traffic impact assessment;

St Ives Indoor Sports Complex

For Ku-Ring-Gai Council

1. 1175 St Ives Indoor Sports Complex – Response to Submissions

2.5m x 5.4m Parking Envelope

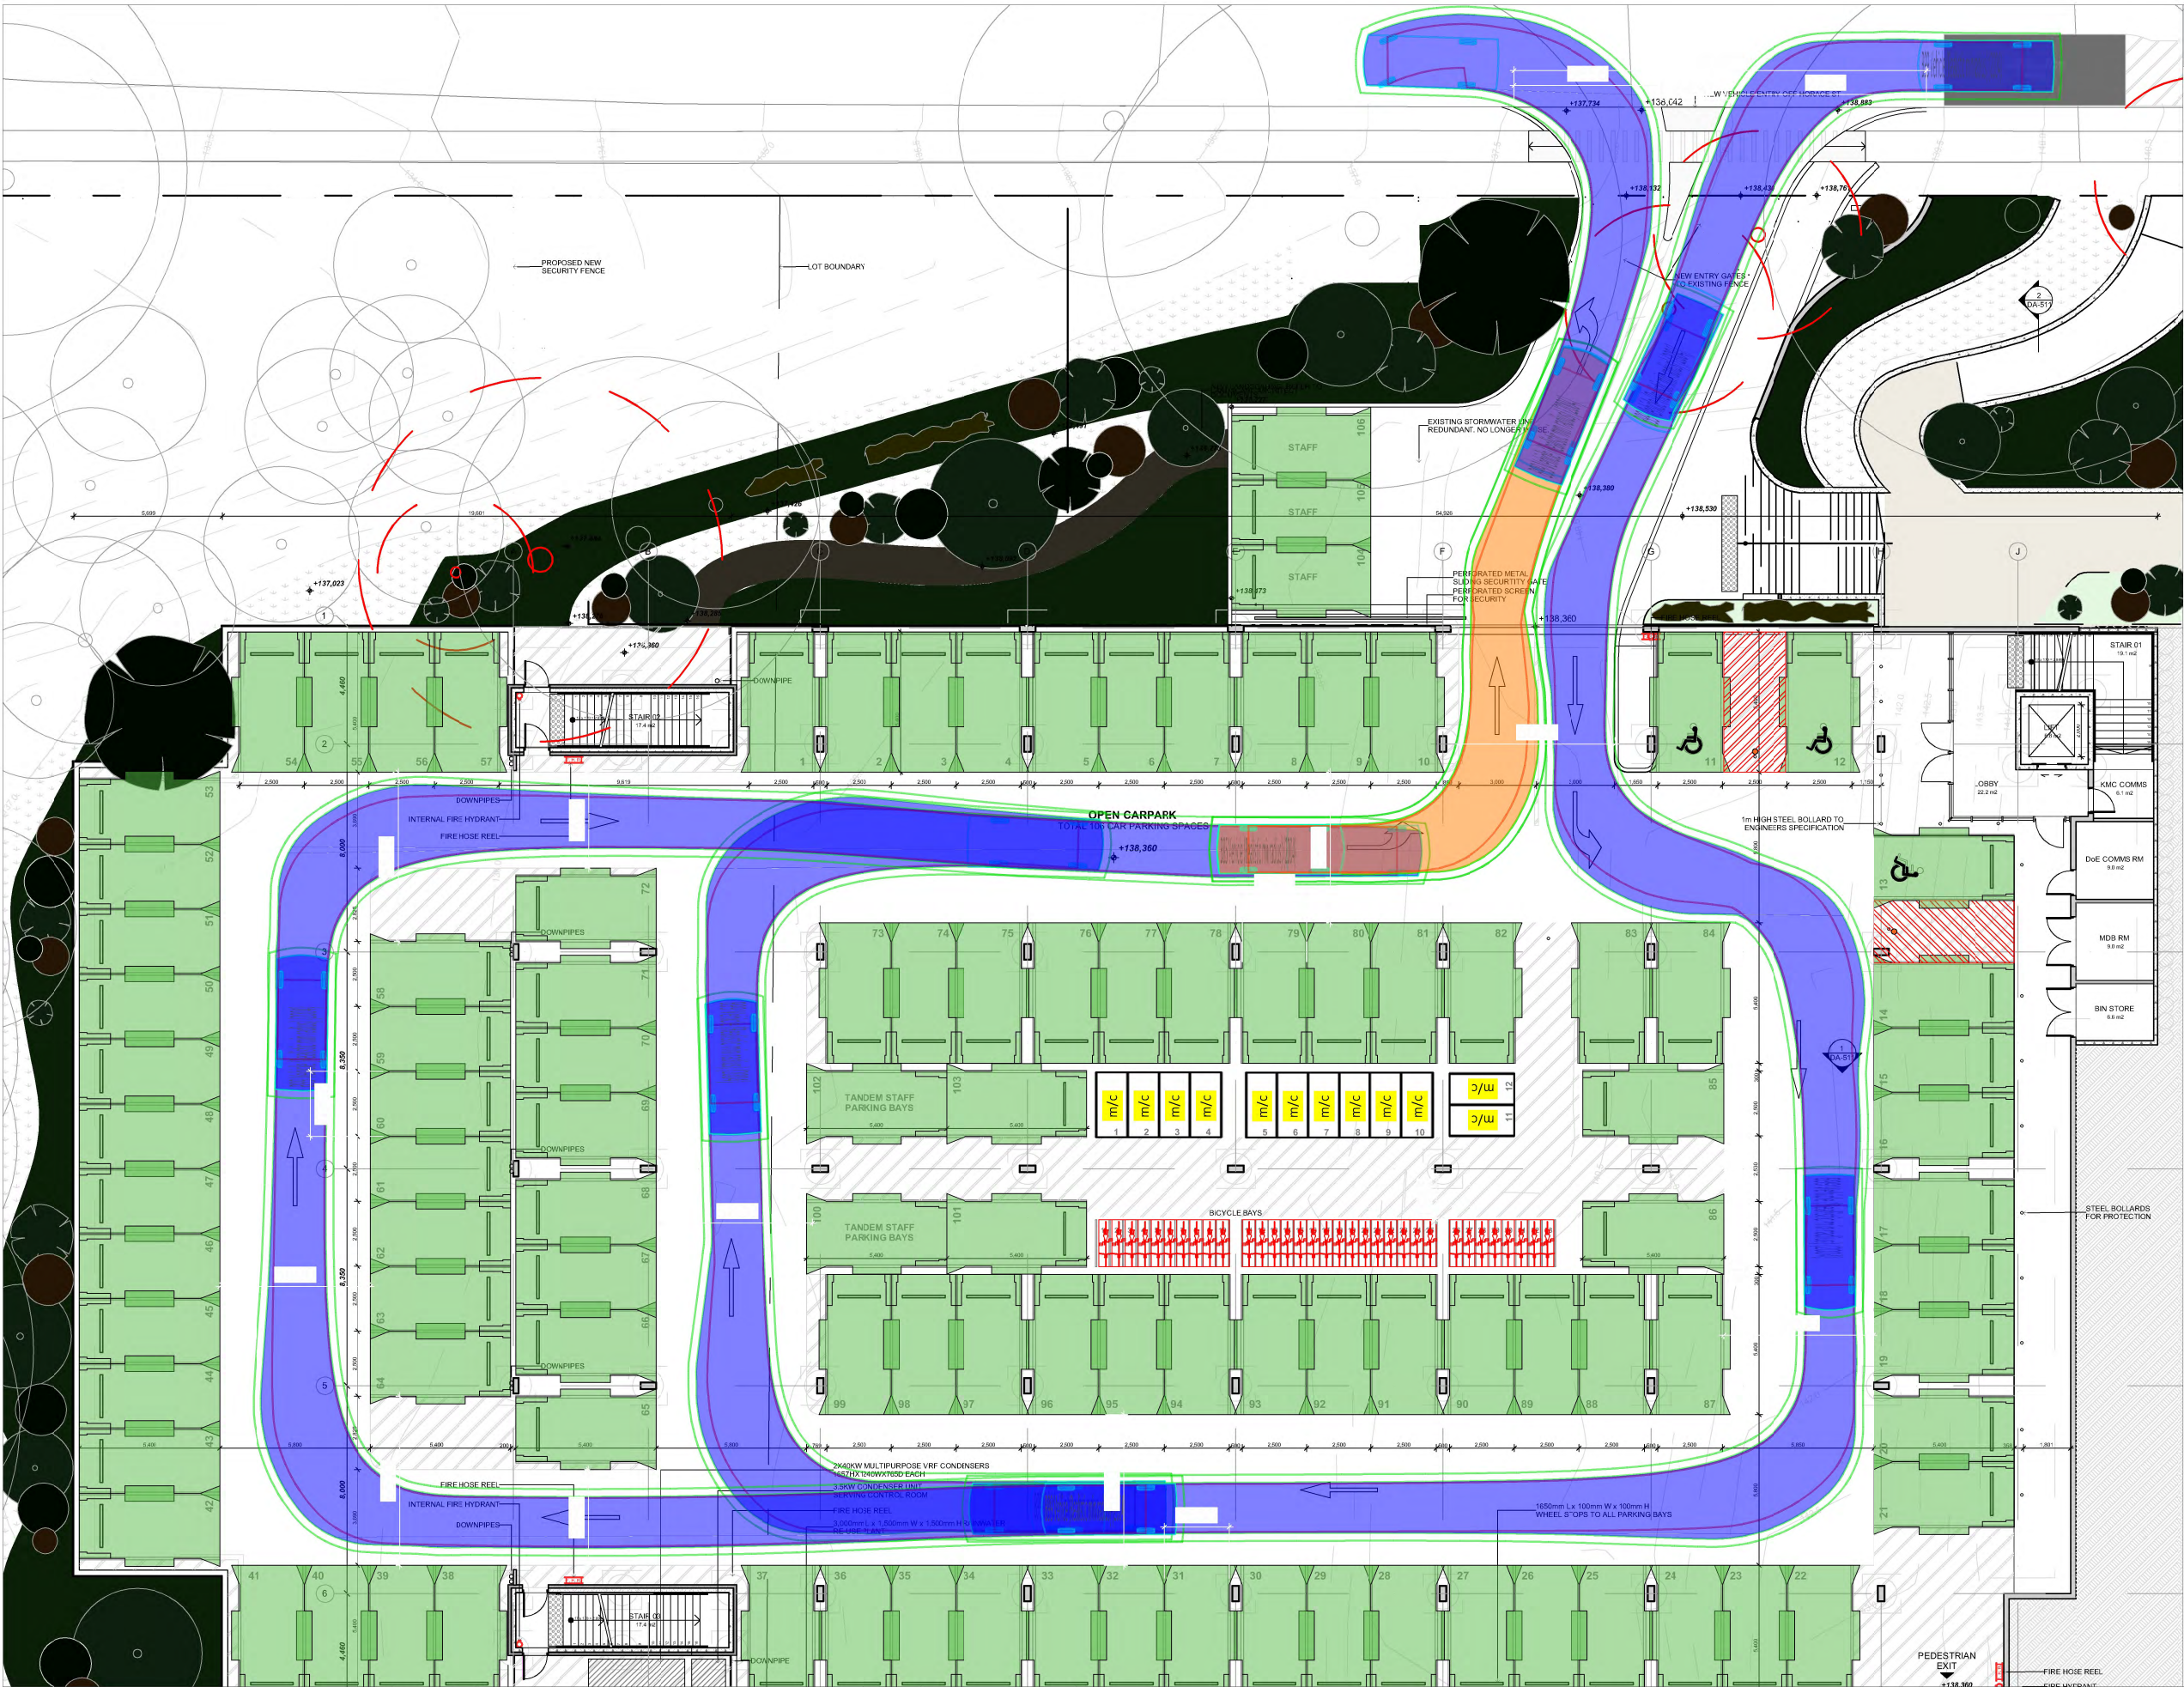
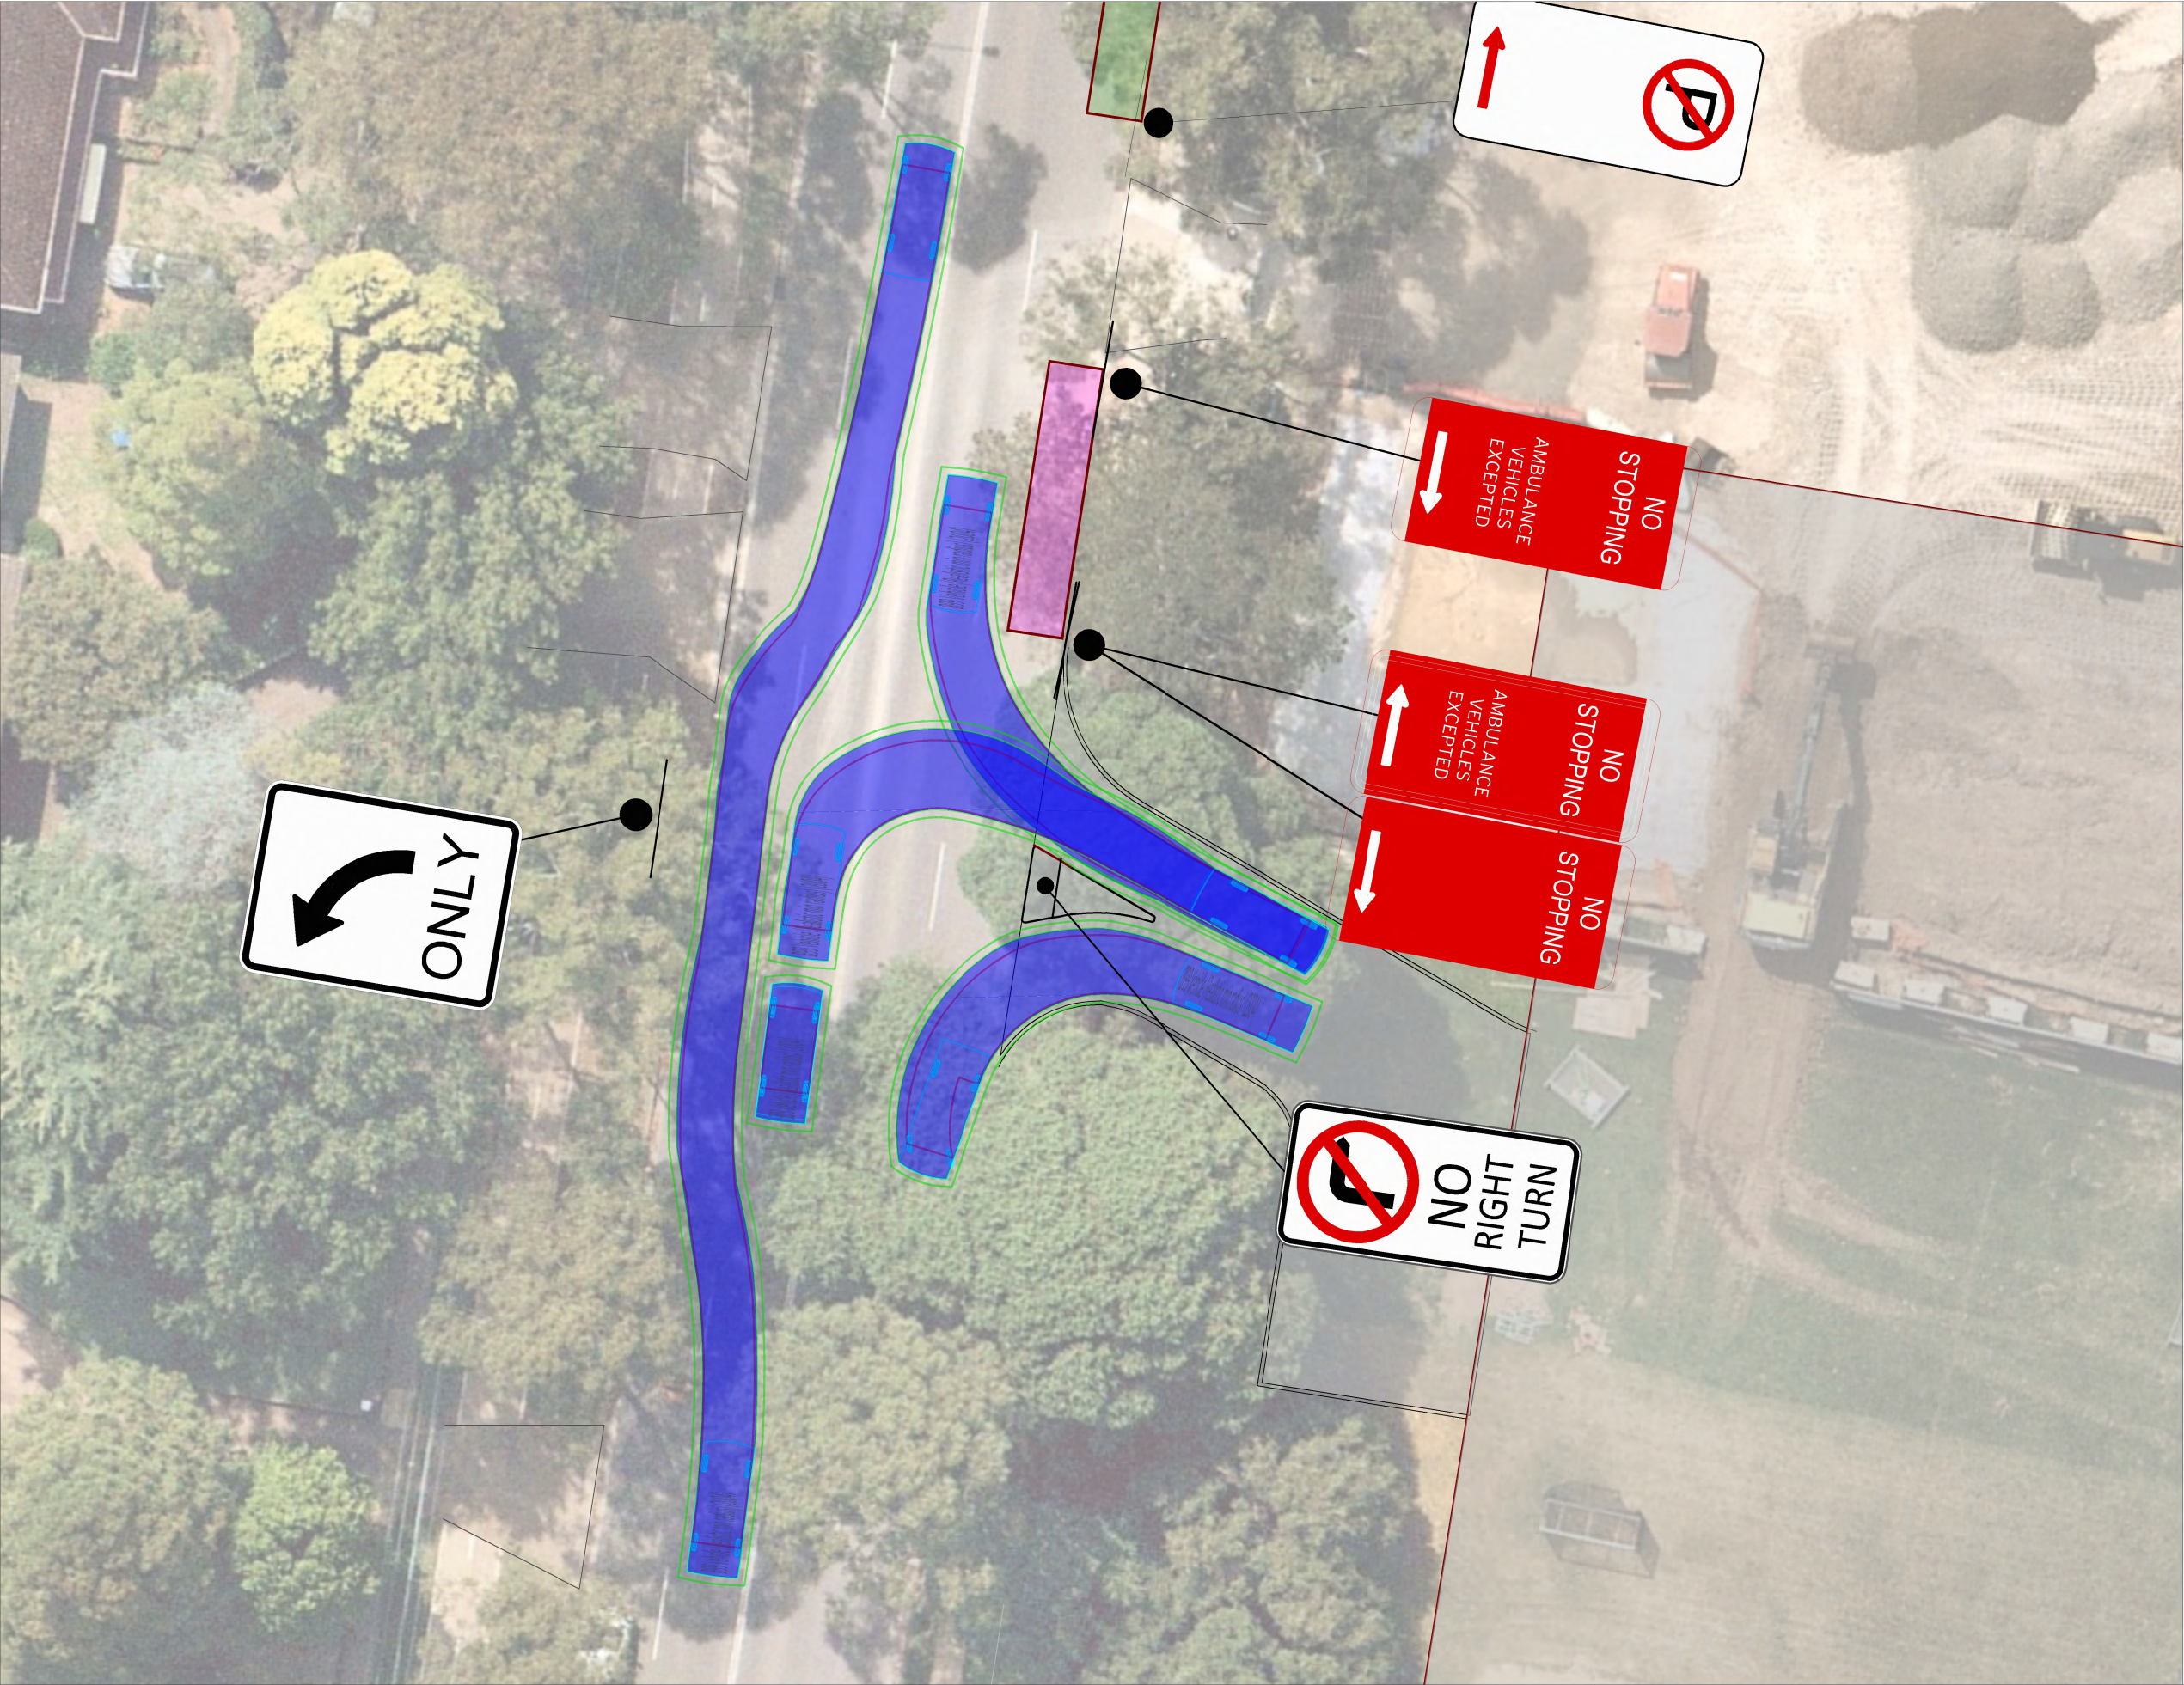
1. There are no widths shown on the parking bays, however they appear to be 2500 wide and these as well as the aisles comply with the AS2890.1 criteria for a "Sports Facility".
ptc. response
The width has been added in the design review drawing in Attachment 5. The bay dimensions are also shown in the legend.
All but one bay are 2.5m wide; one accessible bay is 2.4m wide.

2. The ambulance bay should be moved forward to provide for the stretcher as per the NSW Ambulance Guidelines.
ptc. response
The ambulance bay has been relocated outside the basement car park.

4. There should be wheel stops on the angle bays adjacent to the tandem bays.
ptc. response
Wheel stops have been provided for all but the front tandem parking spaces.

5. The swept path diagram shows very little clearance between cars turning between the driveway and the 1st aisle. The kerb on the corner of the inwards side should be trimmed back to provide for an increased radius turn.
ptc. response
The swept paths have been provided in accordance with the AS 2890., where a minimum clearance of 300mm between two passing vehicles is permitted.

Figure 1 - Use of pick-up and drop-off

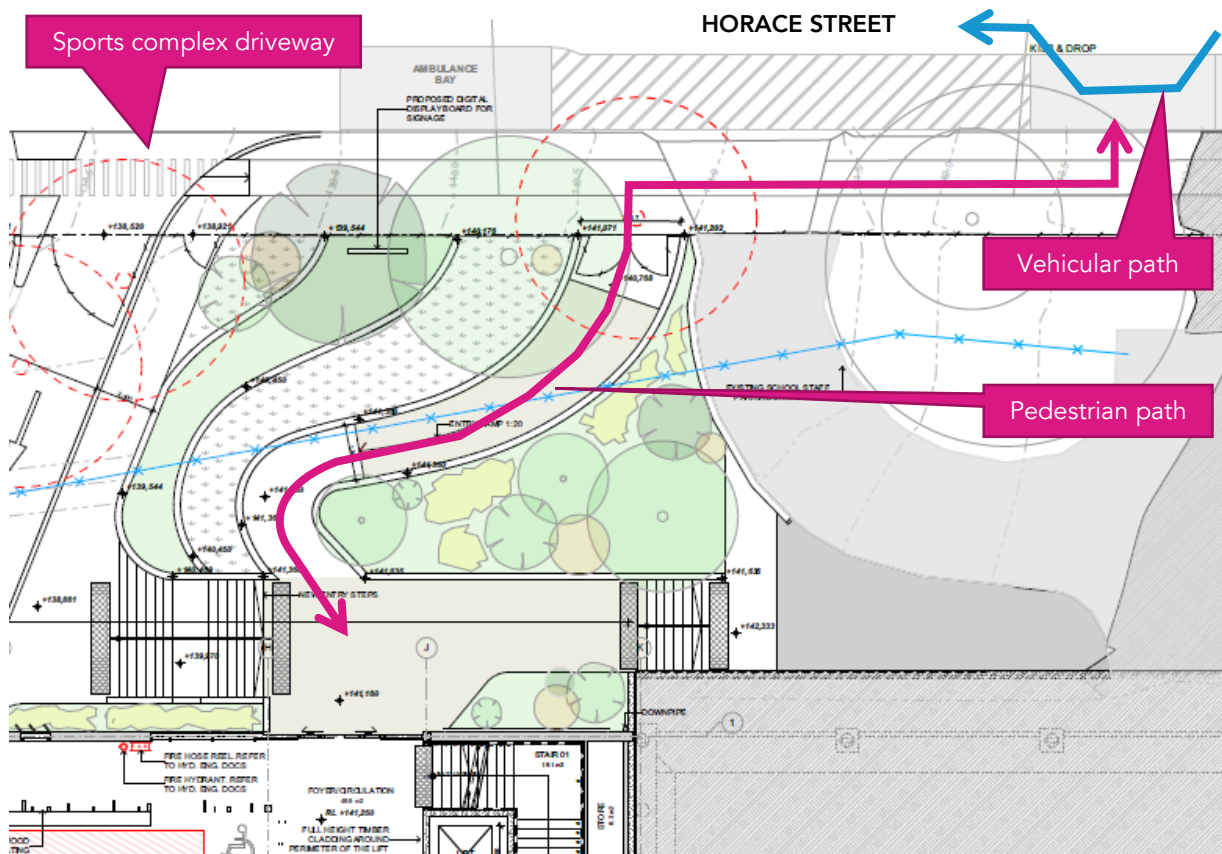
One submission questioned

3. The pick-up and drop-off are located about 40m away from the main entry. Patrons / visitors dropped off will enter the building through the provided footpath – on both rainy and sunny days (refer to Figure 1).

5. Pedestrians will exit the building and use the footpath leading up to the pick-up and drop-off spaces; The vehicles will stop within the pick-up and drop-off spaces. No conflicts are expected during this occurrence (refer to Figure 1). Appropriate parking signage ("No Parking") has been proposed as part of the original DA submission.
This arrangement is similar to a pick-up and drop-off operation at a school pick-up and drop-off.

Figure 2 - Swept Path Assessment

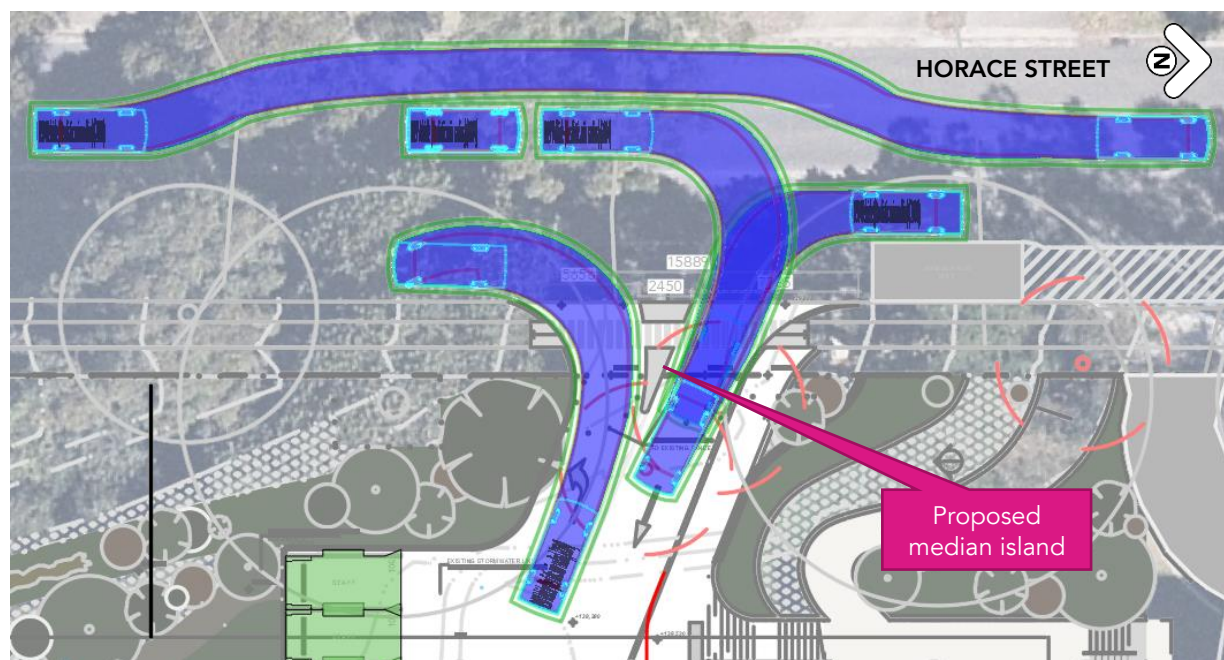
- *How does the median allow right turn ingress but preclude right turn egress?*
- *Will the median be wide enough to provide refuge for pedestrians crossing and if it is, then will this require widening of the Horace Street roadway to accommodate it?*
- *It would appear that there will be some potential in the future due to safety consideration (e.g. limited sight distance due to the crest just to the north) to extend the median to prevent the right turn ingress.*

The proposed median is to be provided along the access driveway and has been designed with the following considerations:

- The median divides the inbound and outbound movements, which results in a reduction in conflicts.
- The median has been designed such that it deters right turn egress movements. A swept path assessment demonstrating the possible ingress and egress manoeuvres are shown in Figure 2. The left only movement will be reinforced by the "Left Only" and "No Right Turn" signage. This is to ensure vehicles egress from the proposed car park in an efficient and safe manner without disrupting the through traffic.
- The median provides for a pedestrian refuge which is 1.2m in width and length. This is to ensure that pedestrians are able to safely cross the proposed access driveway and minimise potential conflict between pedestrians and vehicles.
- The driveway has been designed and will be constructed in accordance with the relevant Australian Standards.

Figure 5 - On-street Parking Availabilities (Source: Nearmap)

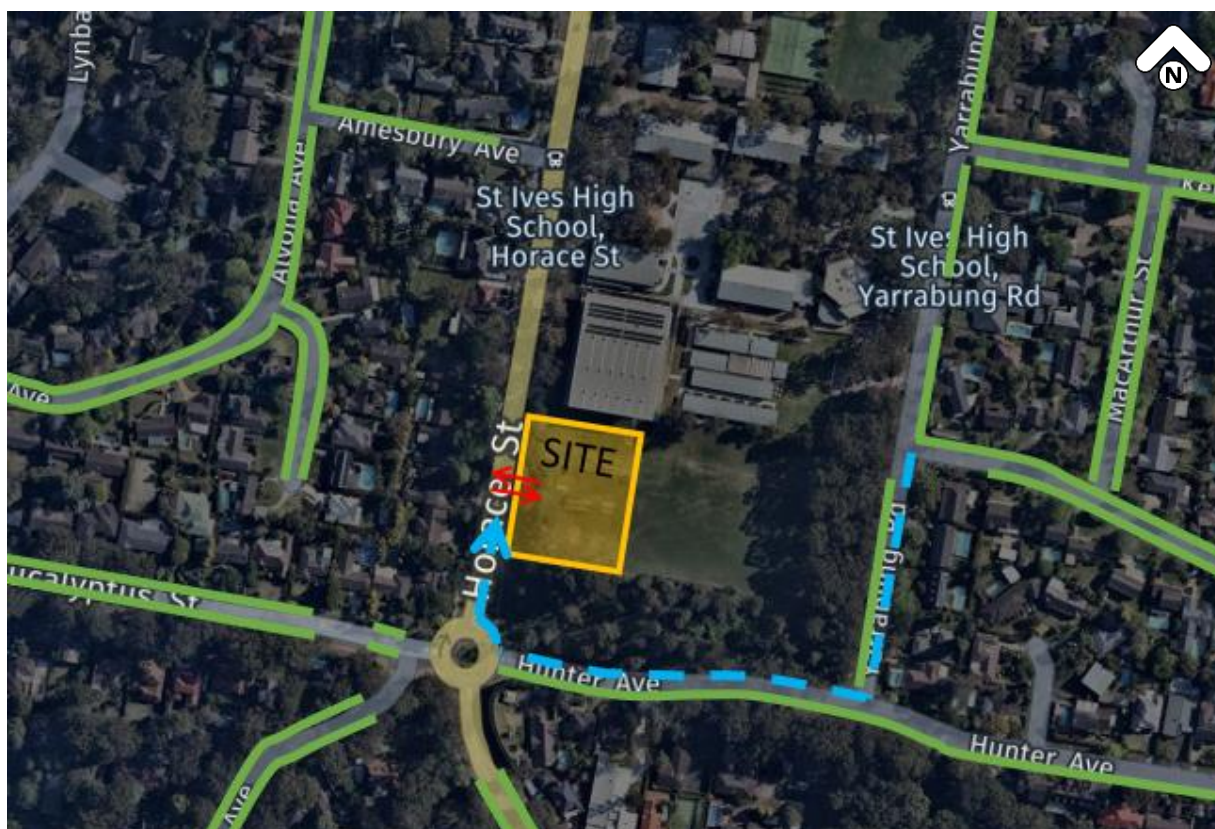
The Plan does not contain anything which indicates how non-bona fide and overstay parking would be dealt with.

A desktop analysis has been undertaken to assess the potential on-street parking spaces that the patrons would be able to use in the vicinity of the site, refer to Figure 5. The analysis indicates that patrons would be required to walk a minimum 100 metres from the closest available on-street parking space along the southern side of Hunter Avenue, noting that the only access to the proposed site is off Horace Street.

Patrons that would park their vehicles along the residential streets towards the east of the site would need to walk around the site to enter the complex, which seems inconvenient (path illustrated with blue dotted line in Figure 5).

In light of the above, it is anticipated that the provision of a dedicated car park for patrons within the subject site will be a form of encouragement.
